ADDENDUM NO. 3

Public Paving, Drainage, Water, Sanitary Sewer, Street
Light & Traffic Signal
Improvements

Intermodal Parkway BNSF to Old FM 156

CITY PROJECT NO.: 103332

PAVING SECTIONS

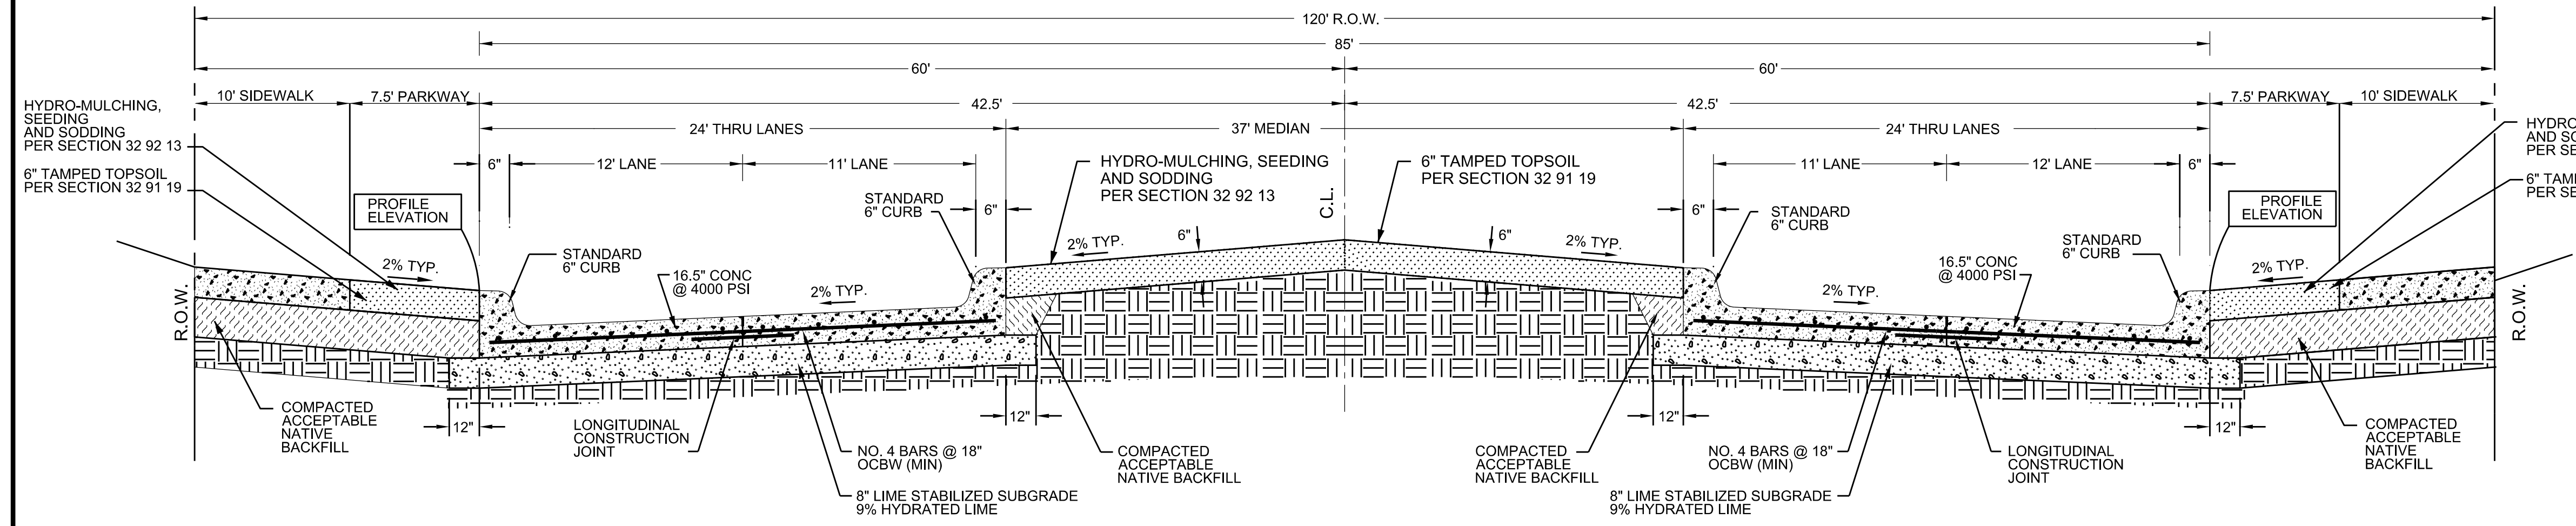
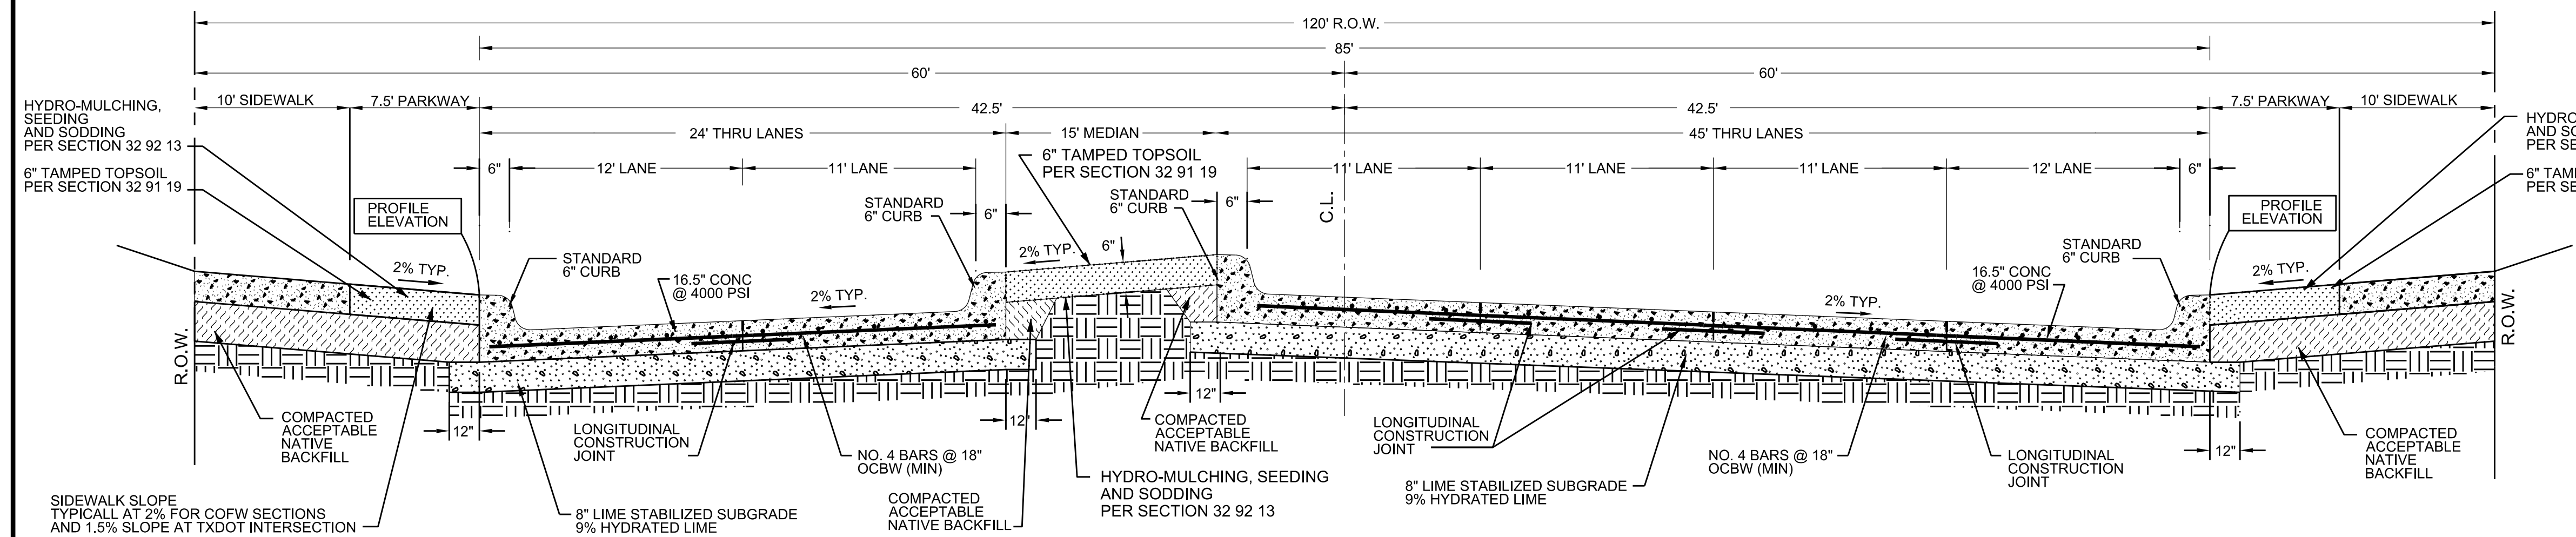
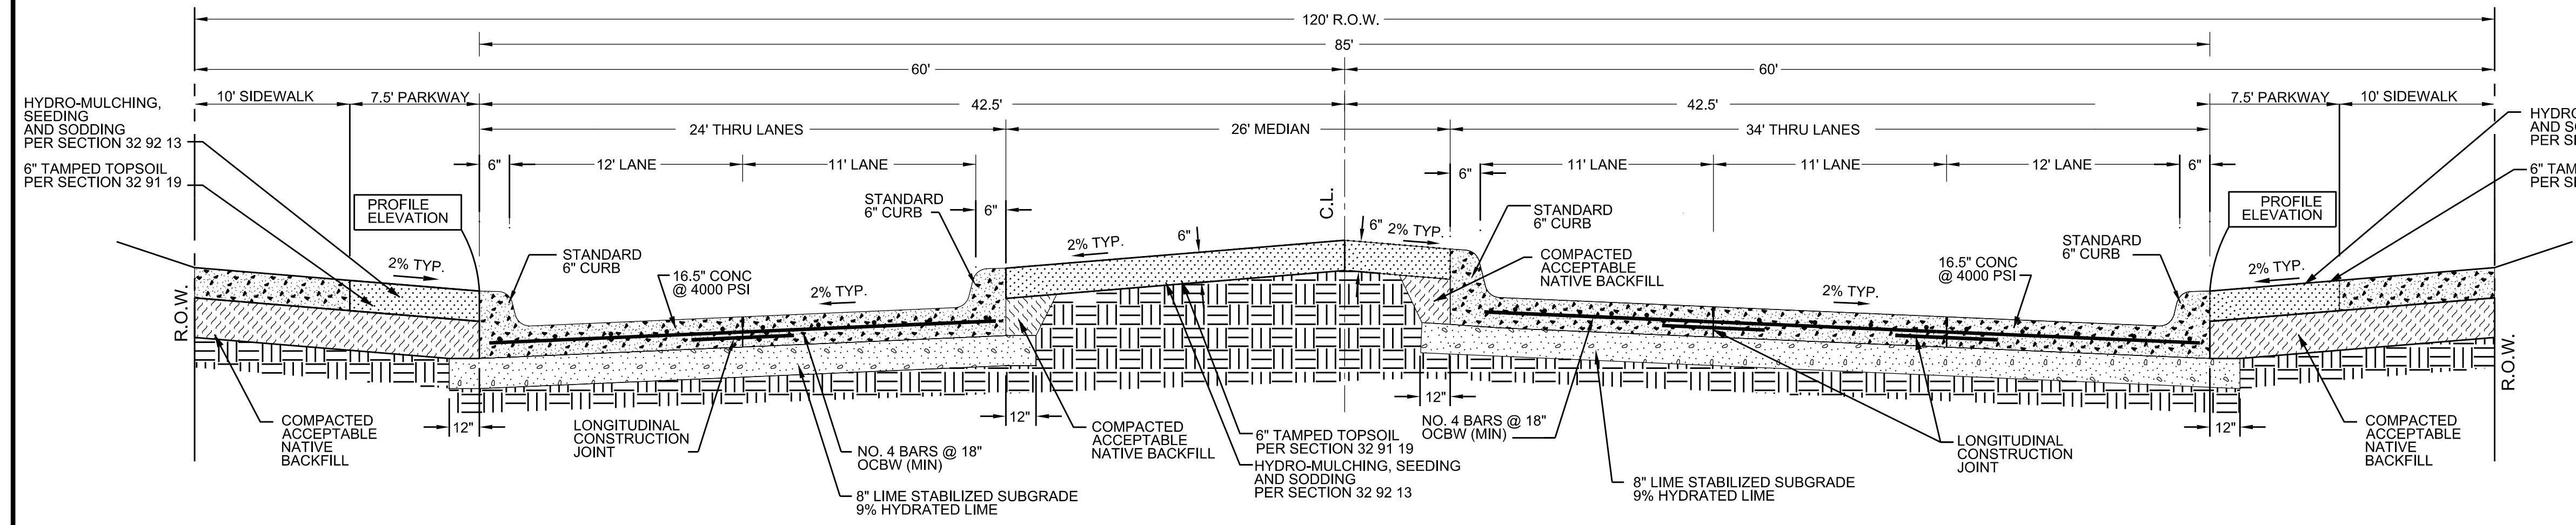
Also, the rebar within the standard concrete pavement detail has been updated to reflect #4 bars @ 18" O.C.E.W.

CITY OF FORT WORTH, TEXAS
EXPANSION JOINT

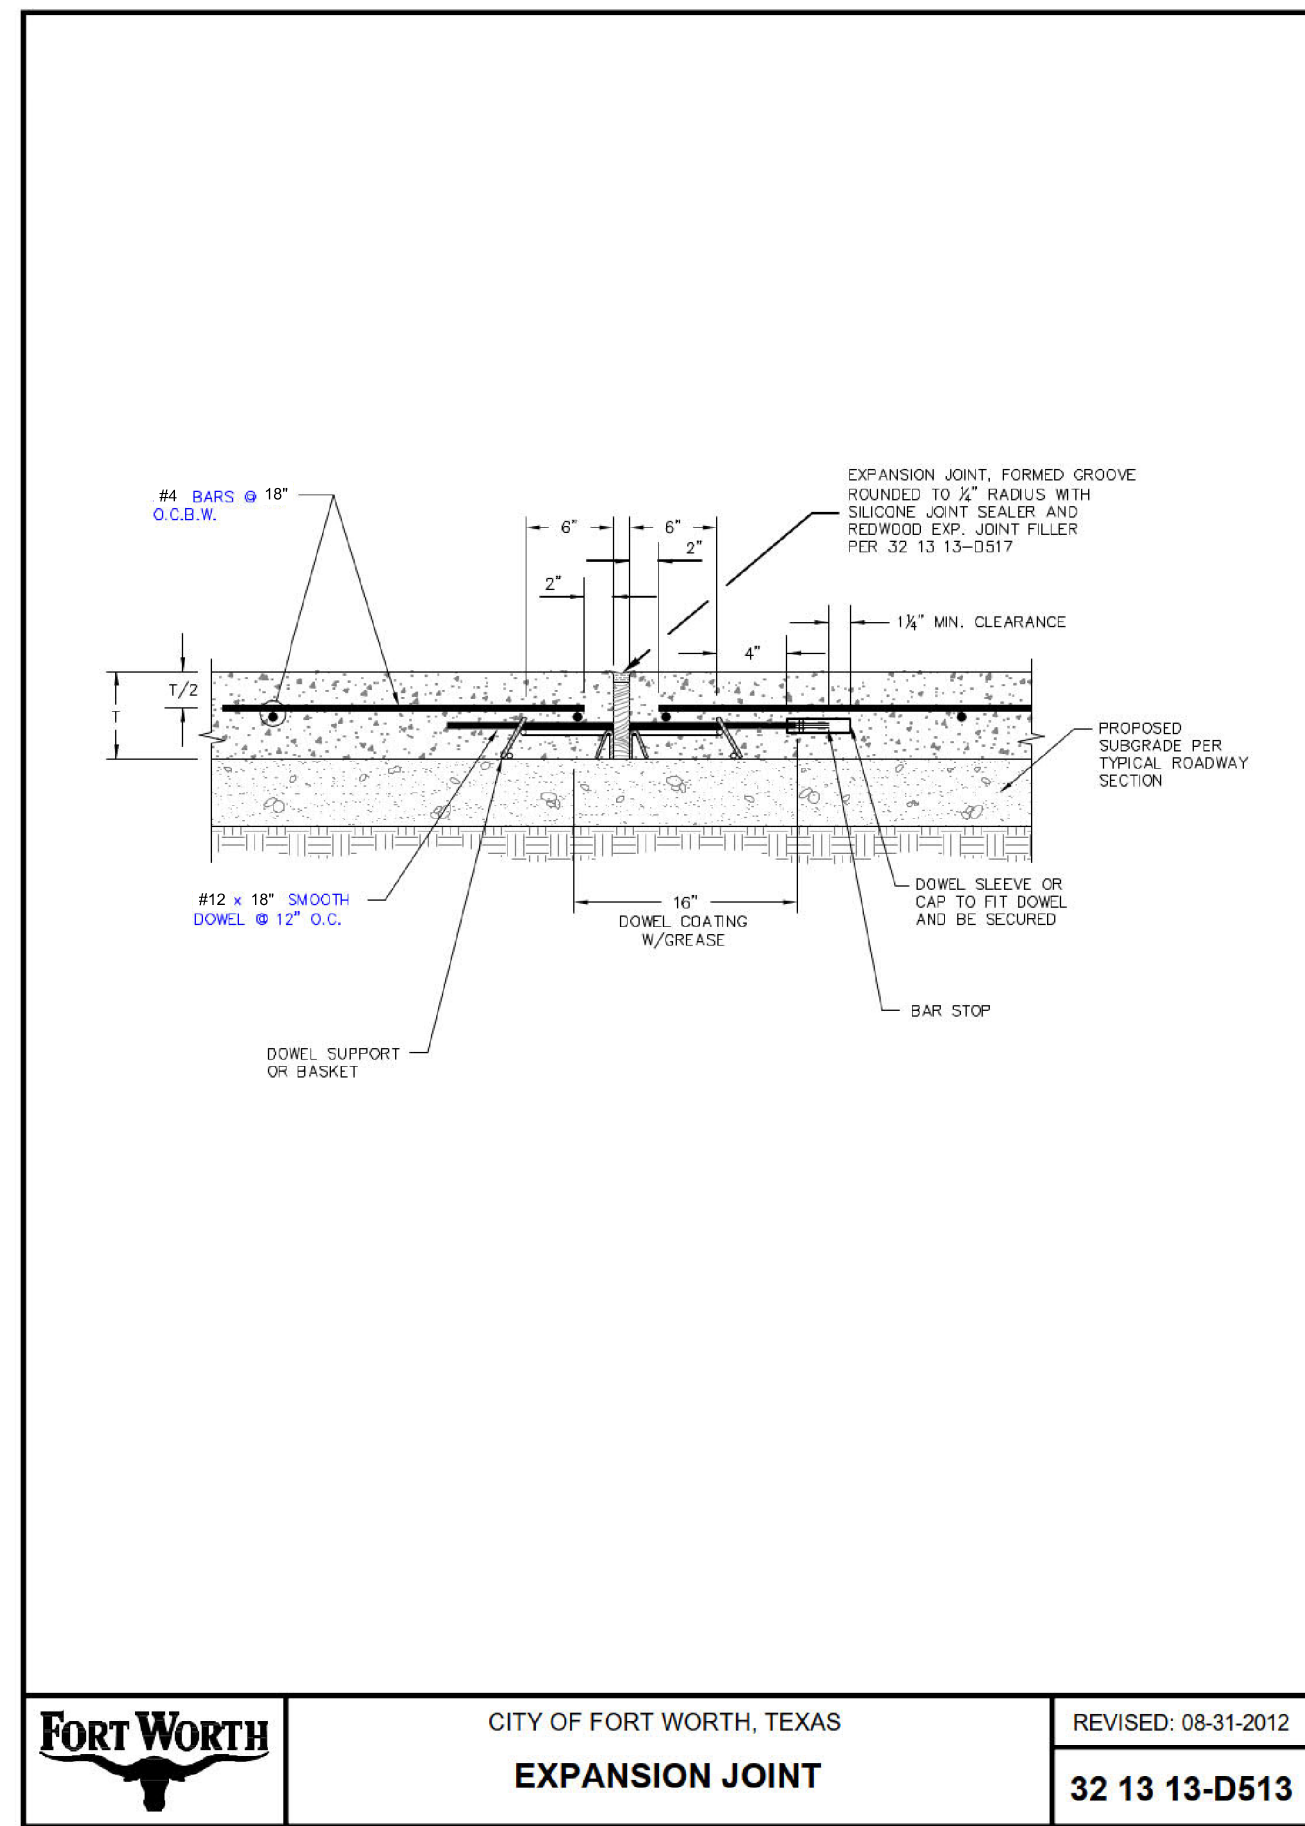
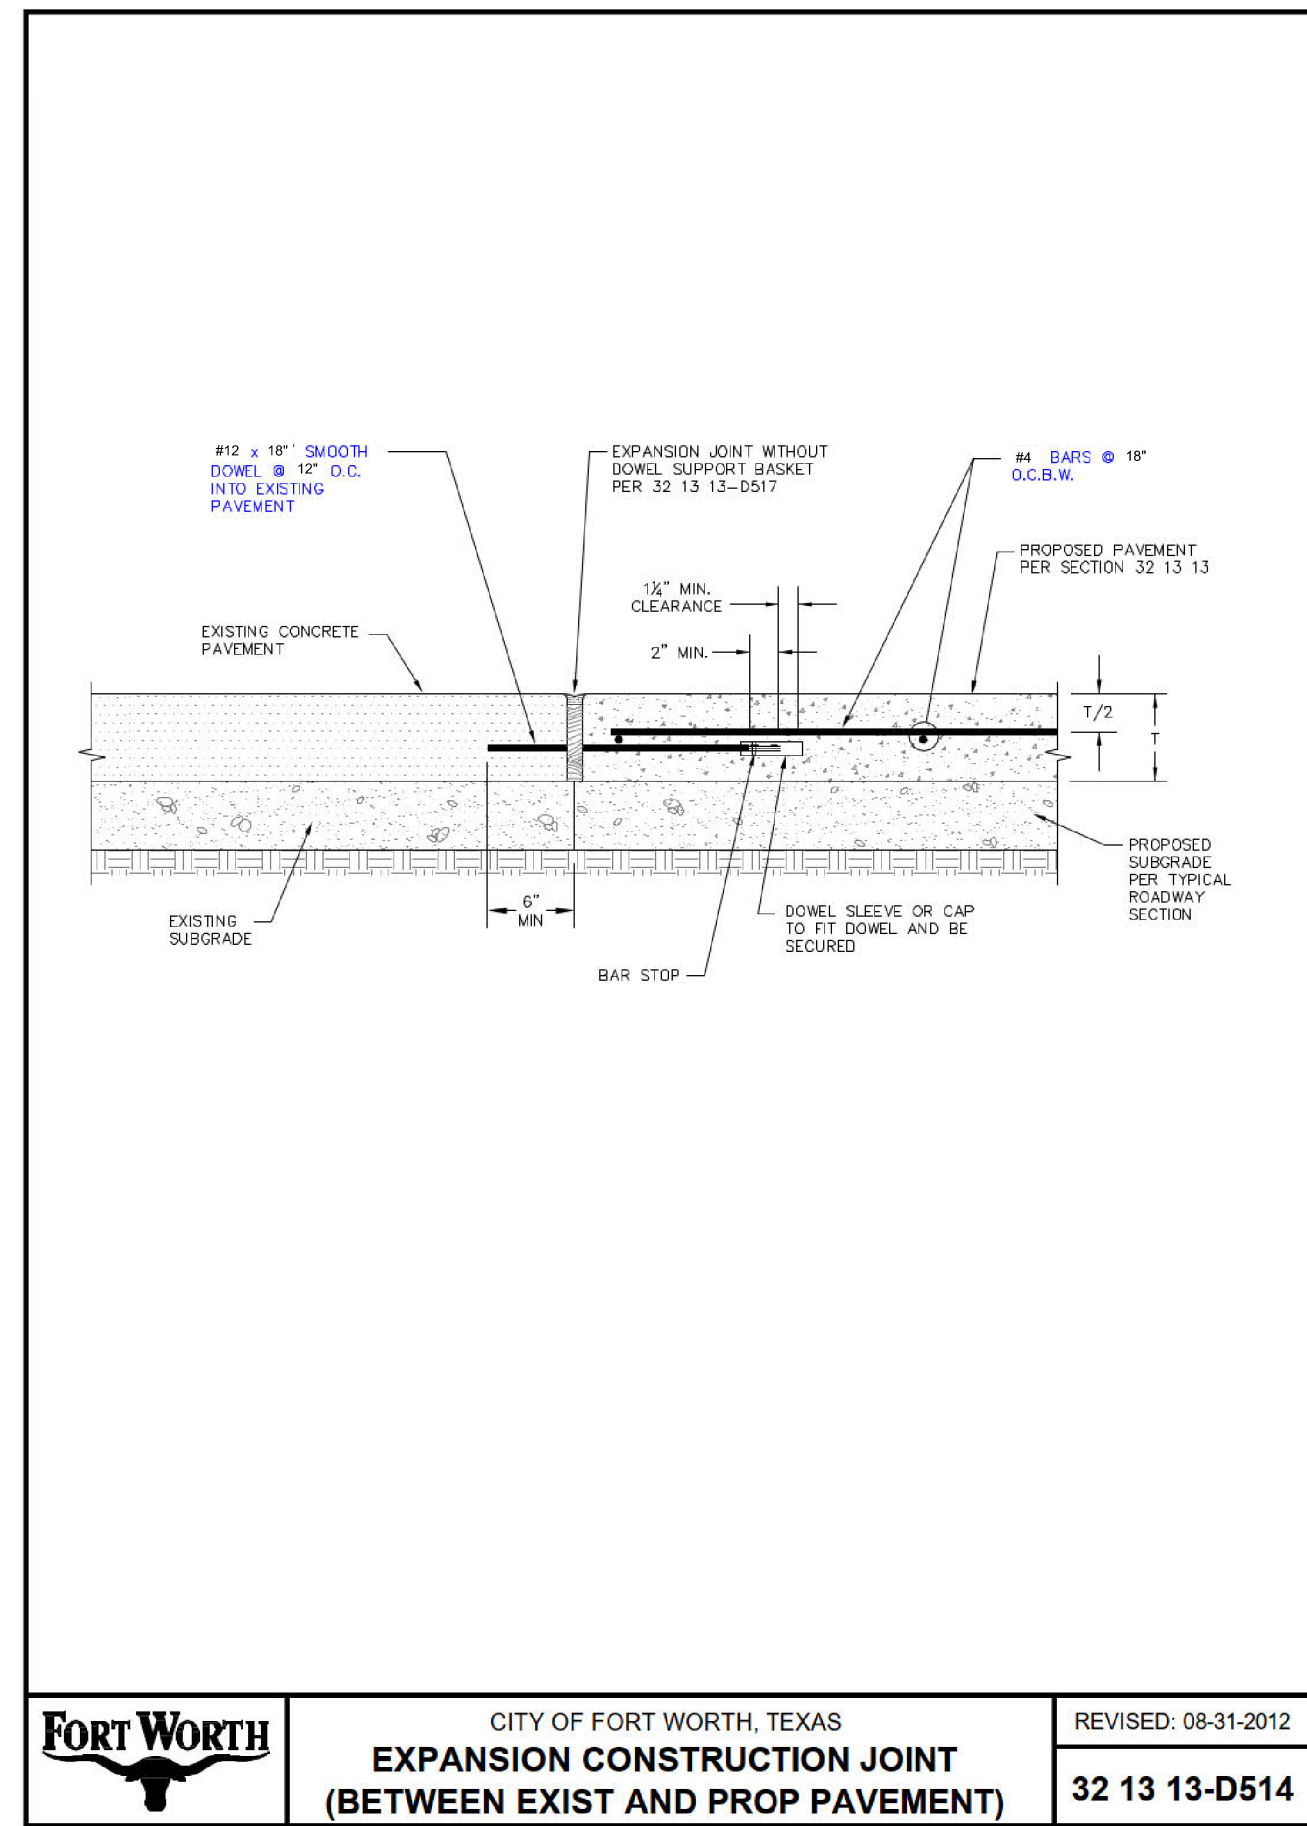
Description of Change: Addendum No. 2 identified the expansion joint details. Since that Addendum No. 2, the Geotechnical Engineer has notified the design team a re-design for the expansion joint dowels as such: #12 bars @ 12" O.C.E.W and 18" in length.
